CITY OF OREGON CITY HISTORIC REVIEW BOARD AGENDA

Staff Report

GLUA-22-00004 and HR 22-0001: Historic Review for modification of HRB decision HR-20-04.

REQUEST: Historic Review for a revision to the location of the detached garage and tree mitigation plan for a an approved (GLUA-20-00007: HR 20-04) single family home and detached garage in the Canemah National Register District.

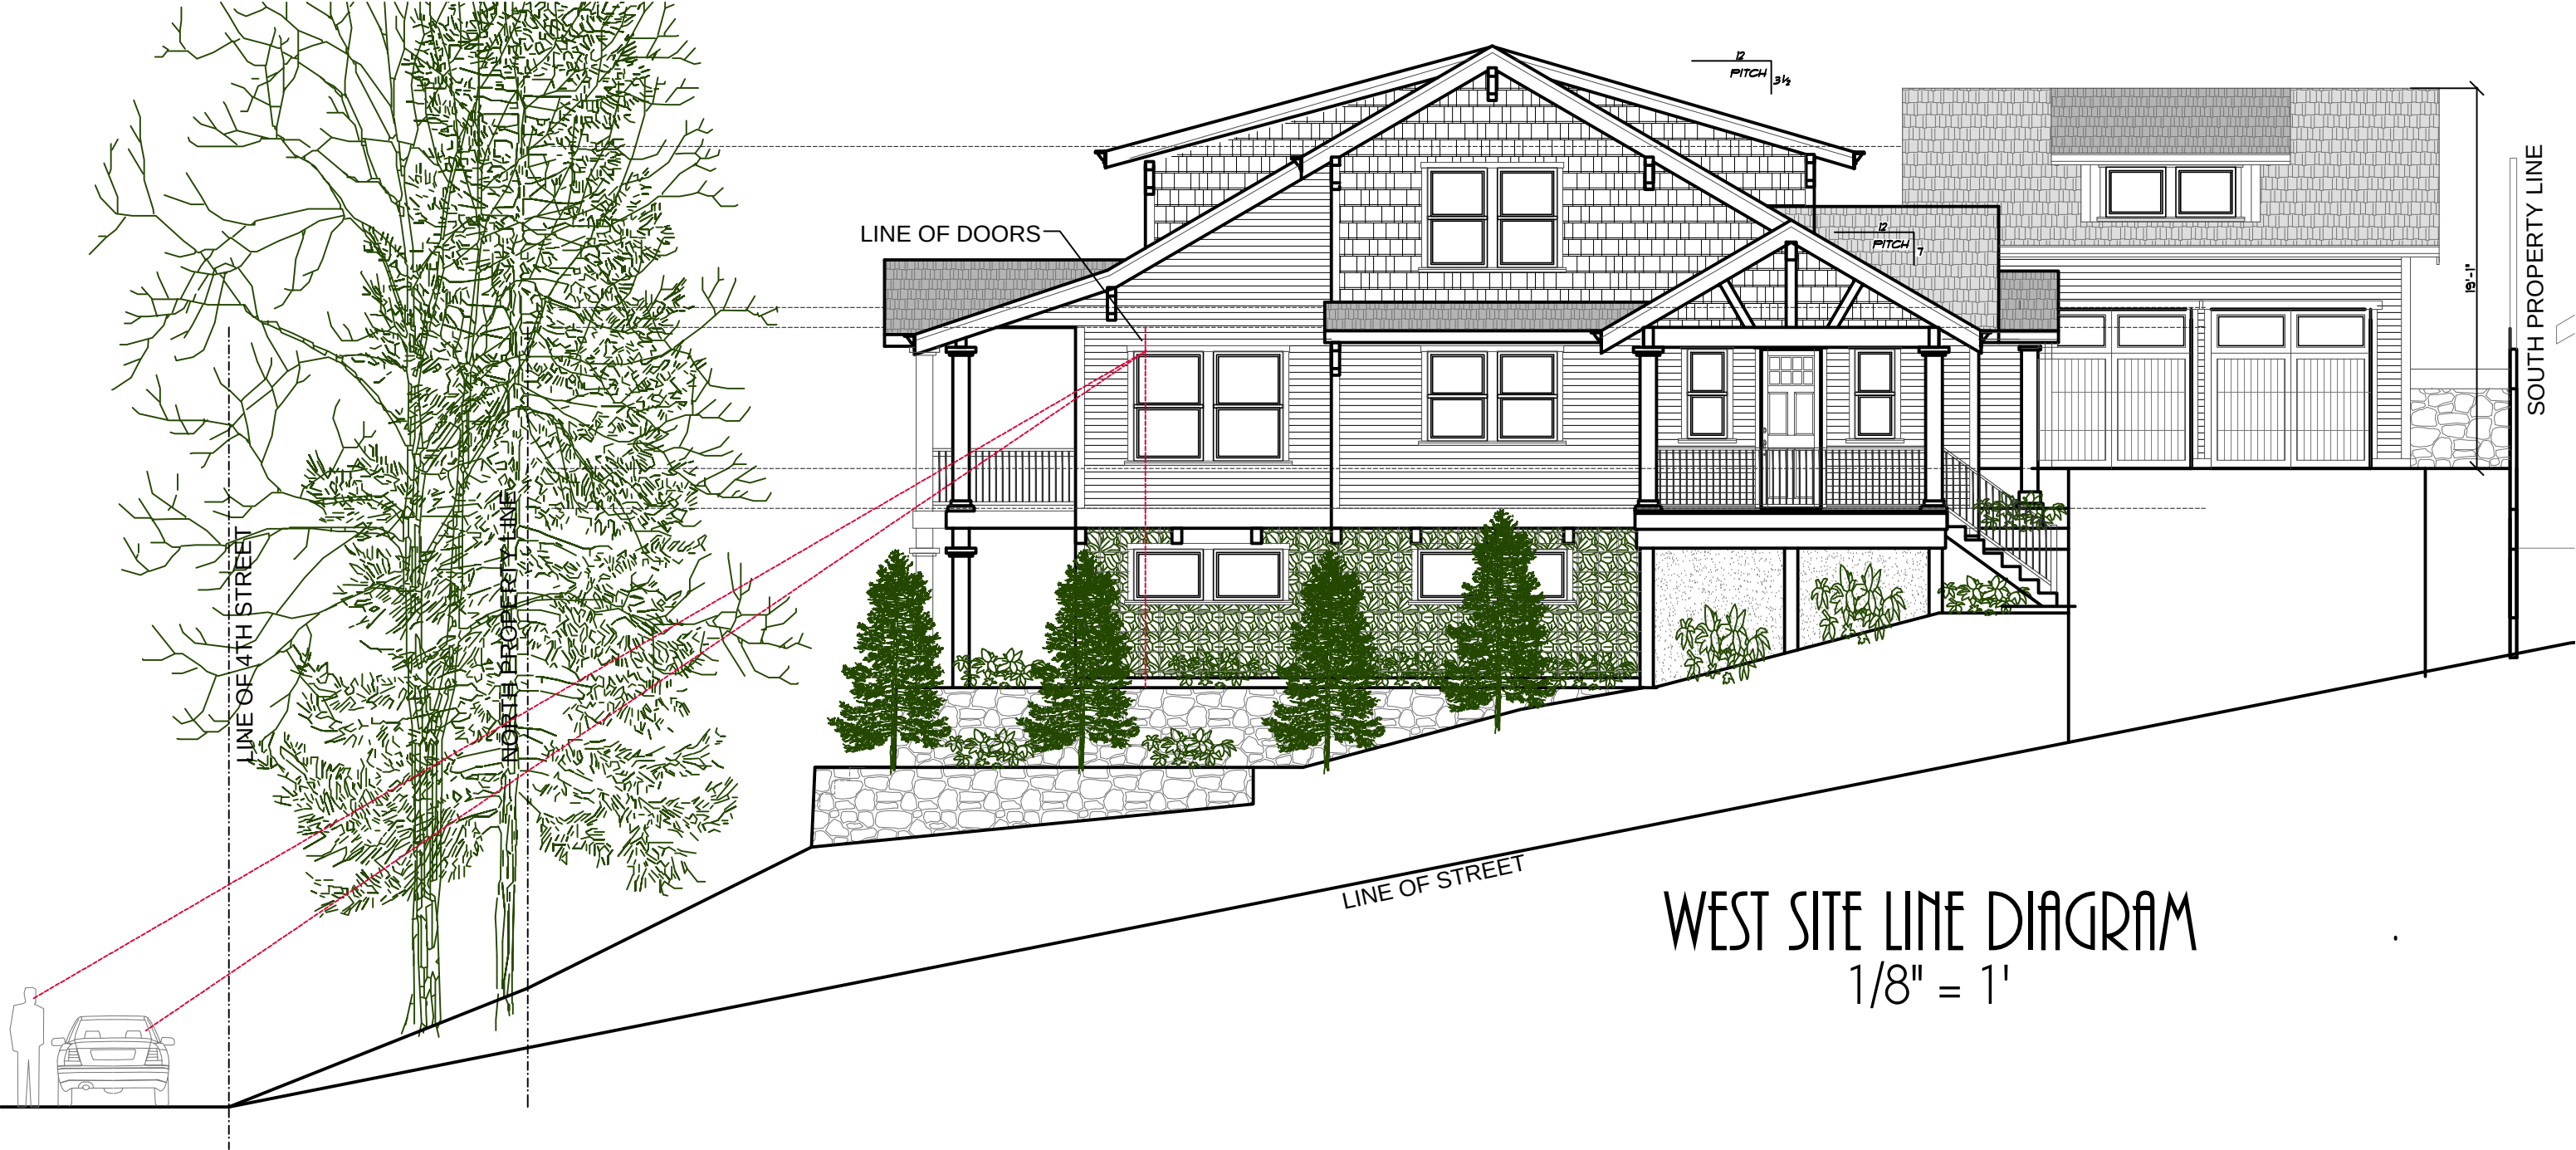
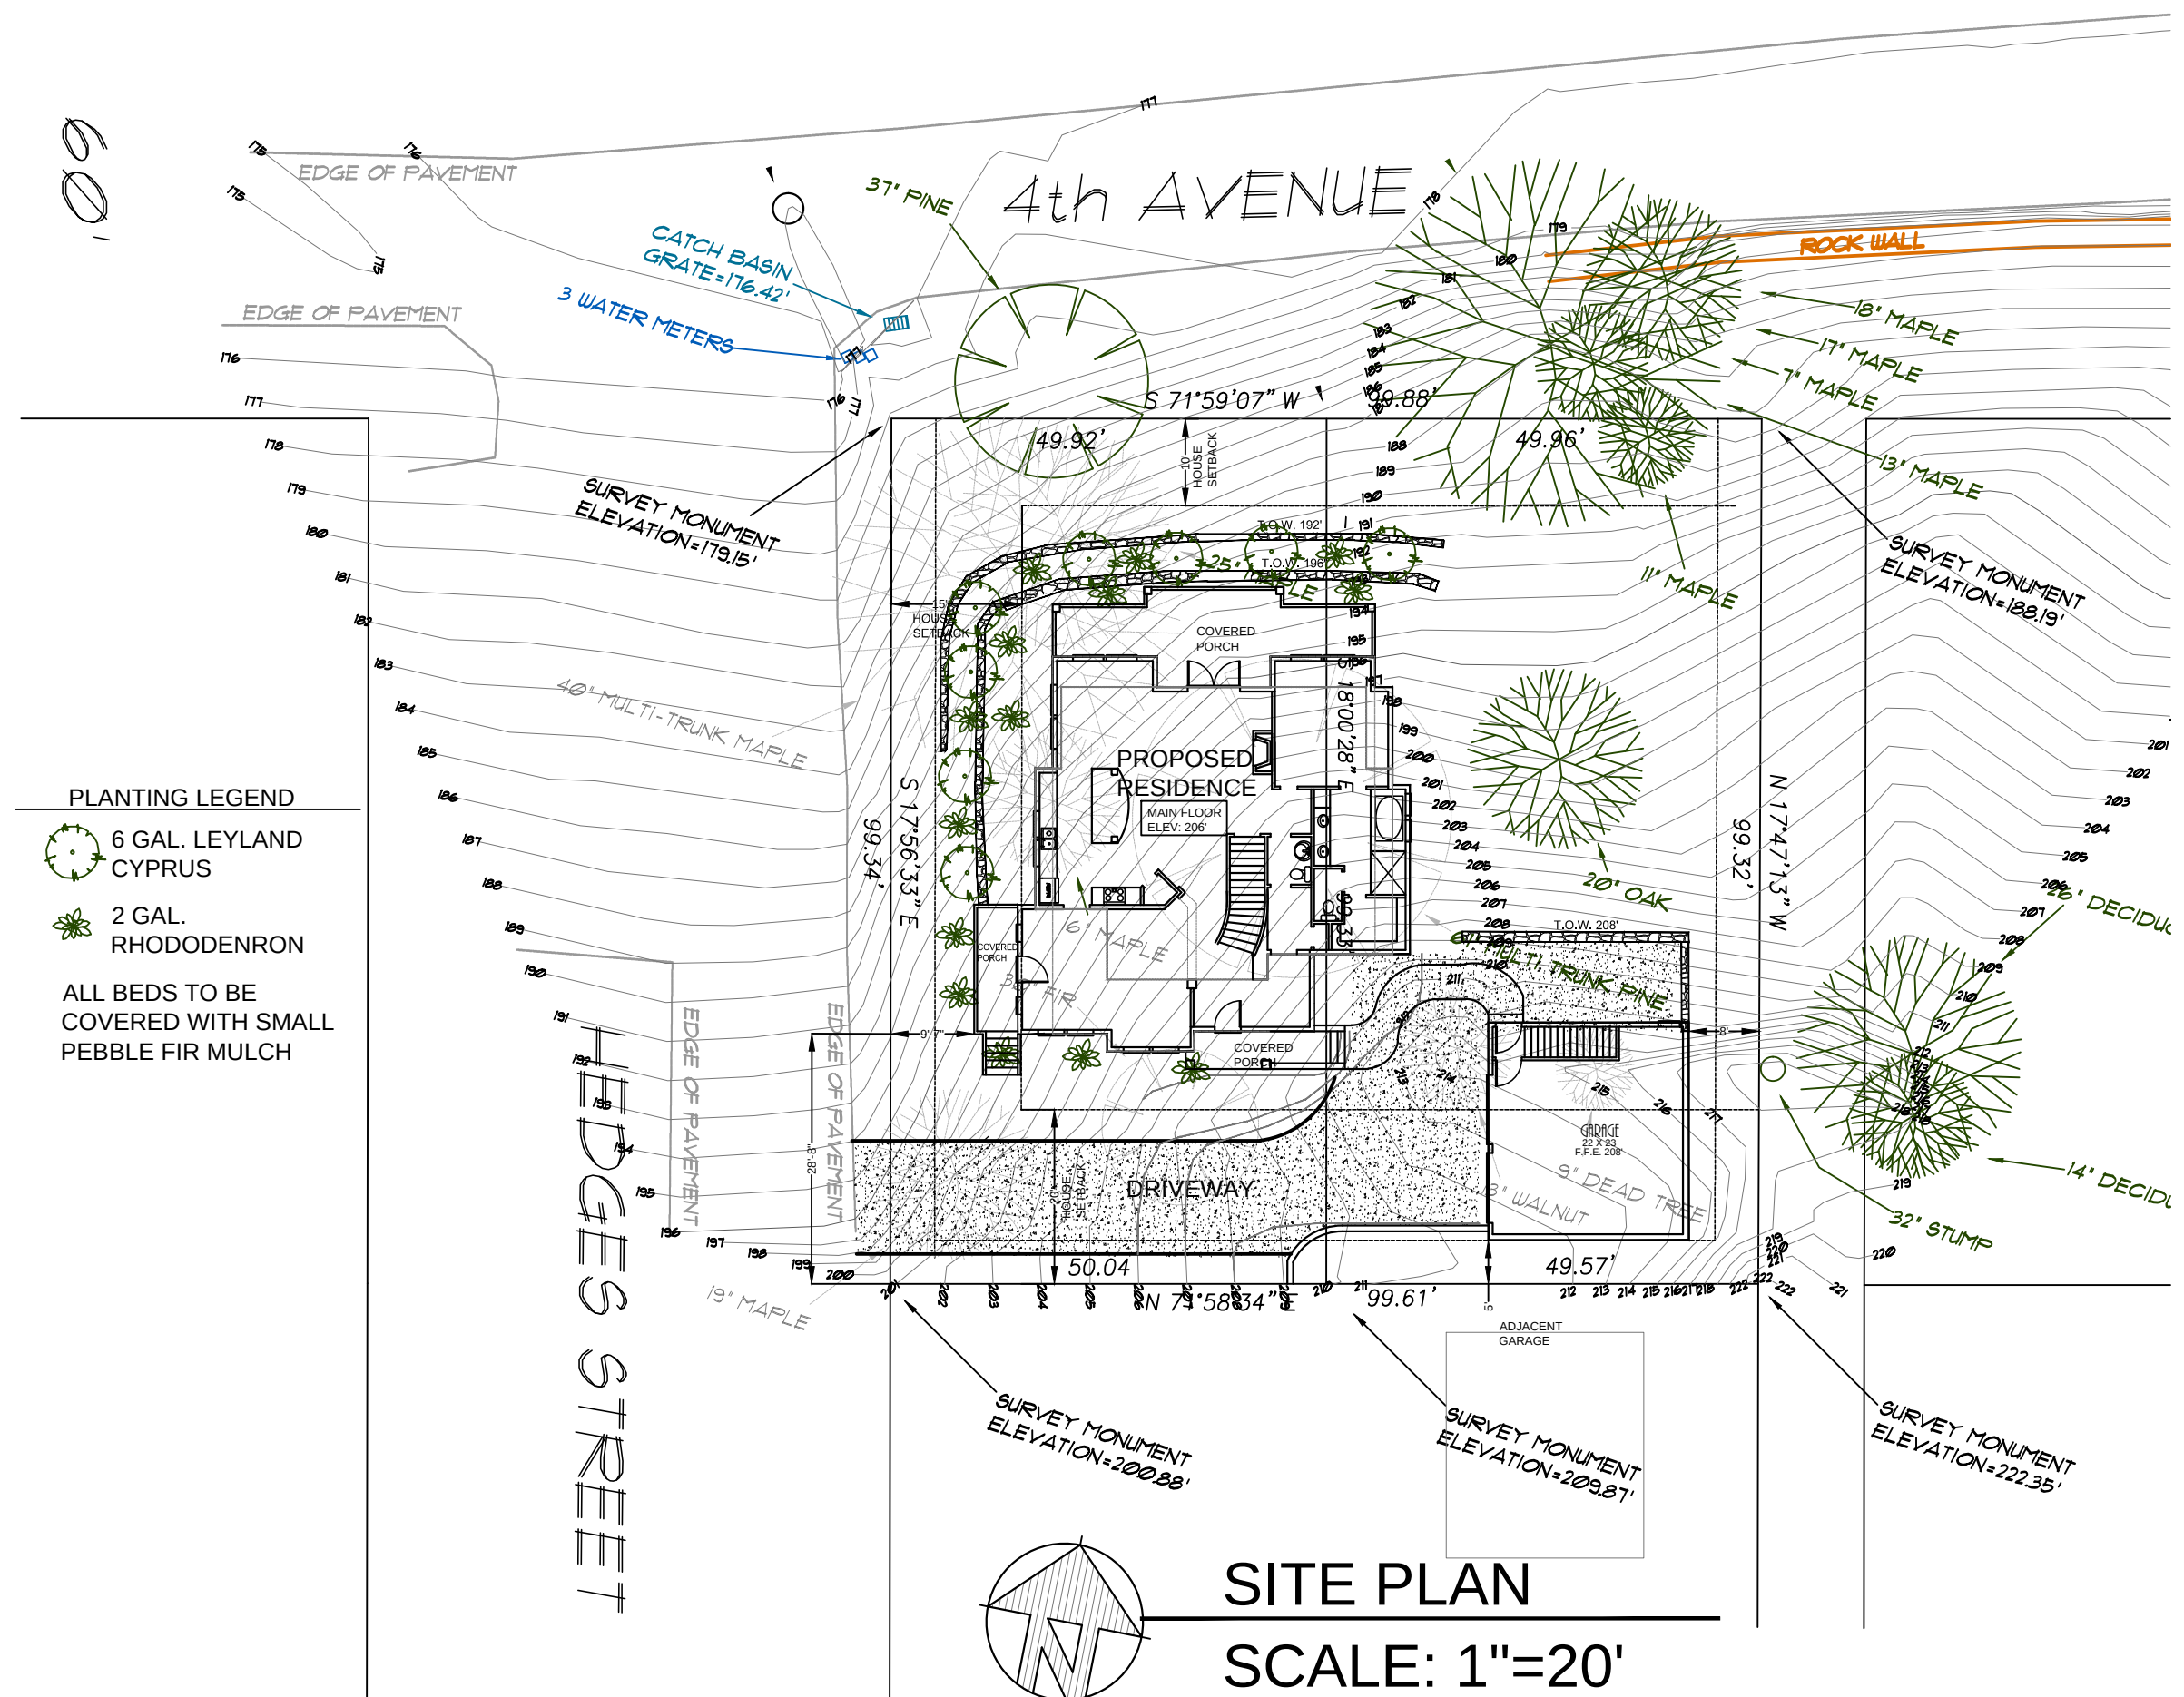
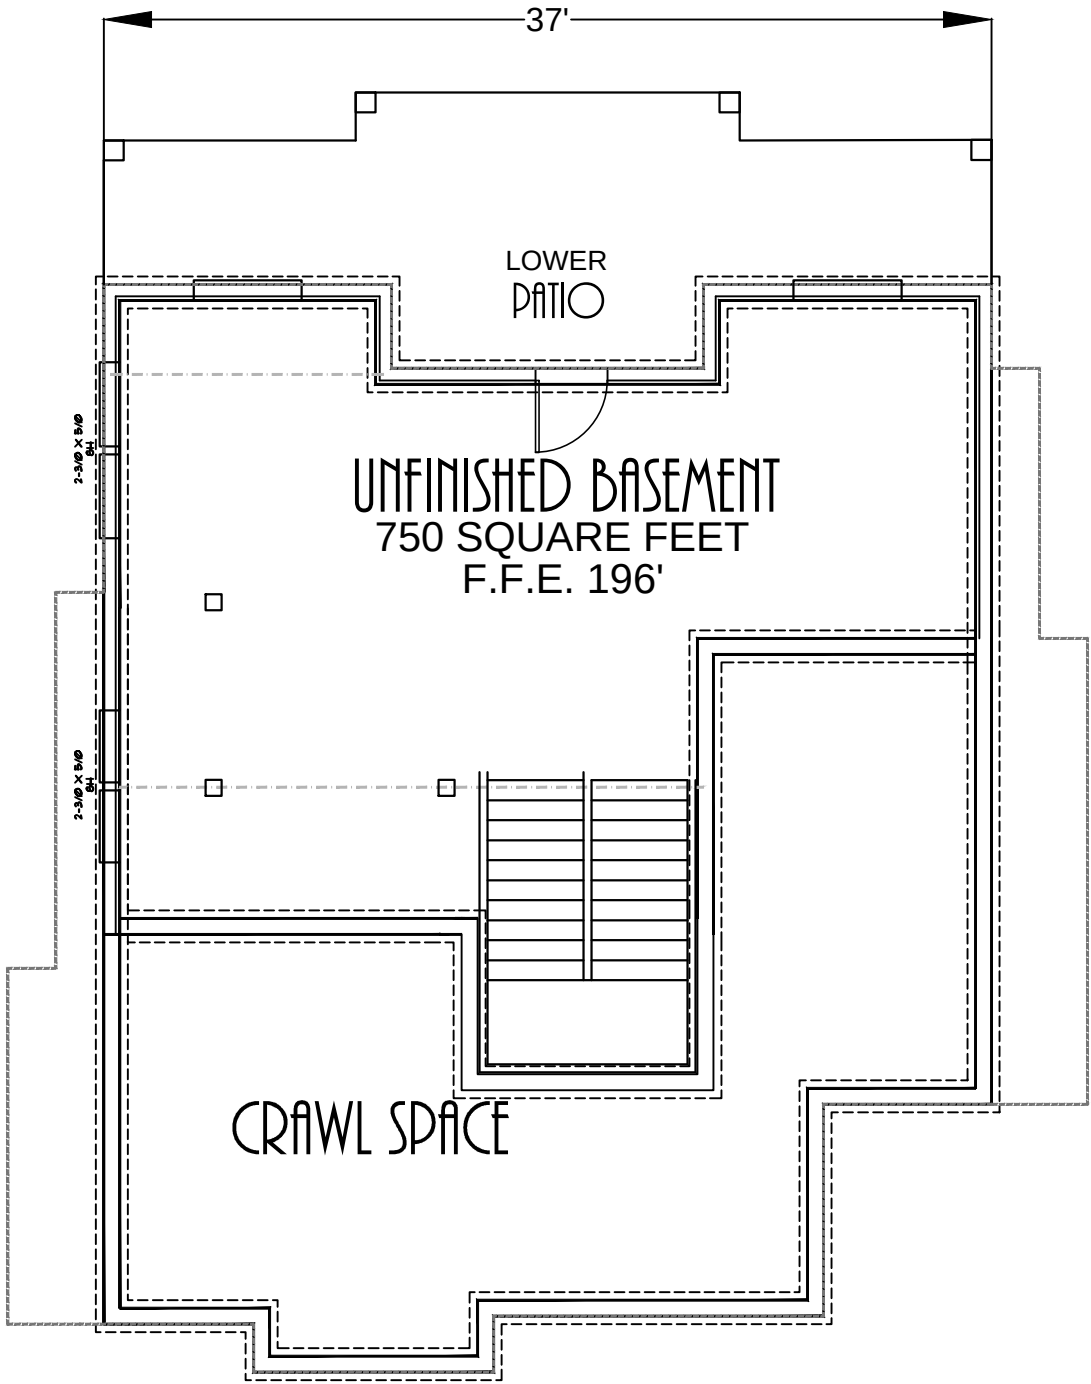
8. We have attempted to mitigate the exposure of the

lower level by reducing windows, adding concrete up higher, and adding metal trellis work for vine plantings. We are open to additional mitigation in regards to this concern within the real geometry that we have been handed.

14. We have reduce the grade width of the house to 37' as stipulated.

Site Plan (Revised – March 2020 Plans)

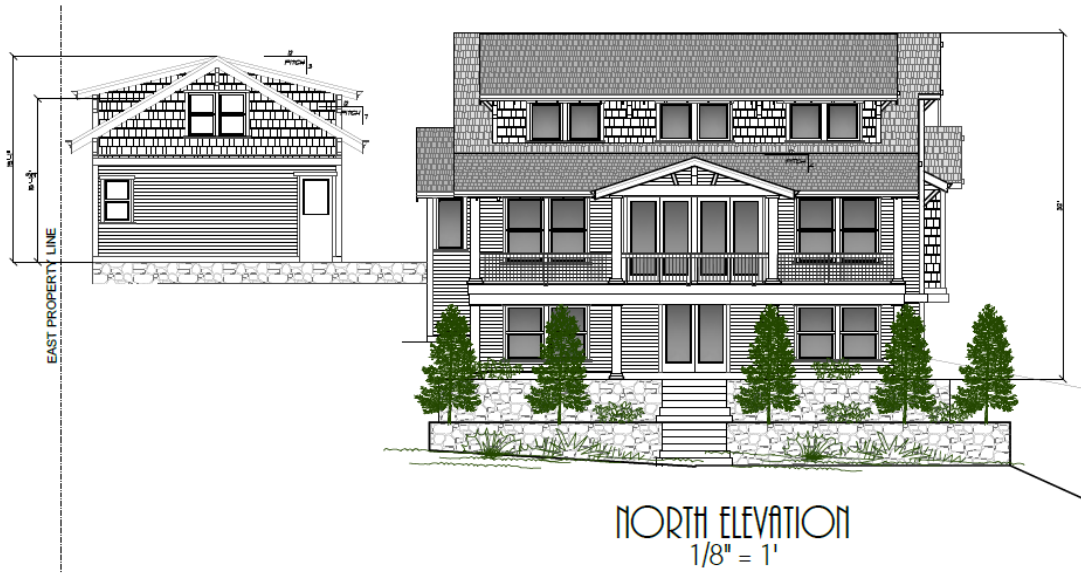
On March 23, 2020, the applicant submitted a revised plan with a reduced front porch width of 40 feet that widens out to 48 feet with bump-outs on the side elevation. It appears that the West elevation (Corner Side yard-Hedges) is cantilevered, and the East elevation (internal side yard) bump out is at grade. These revised plans can be found as an exhibit to the staff report. The length of the revised house is a little over 45 feet which includes an approximately 2 foot rear bump-out on the South elevation

The revised floor plan is a square/rectangular shape with a footprint of approximately 1790 square feet. The proposed porch width is 40 feet, with a depth of a little over 45 feet. Staff has provided a rough analysis of the majority of the existing historic bungalows in Canemah (see images in Exhibit 4) and determined that the footprint of the home is significantly larger than other bungalows in Canemah. The footprint is larger than any of the historic examples except for 602 1st Avenue, which has a footprint of approximately 1900 square feet. The average historic bungalow footprint is 1323 as shown in the table below.

Staff recommends that the Historic Review Board conditionally approve the proposal if the applicant revises the plans to demonstrate a maximum house width of 37 feet at grade. Staff also recommends conditions to address tree removal, the front entry design, basement level design elements, and materials.
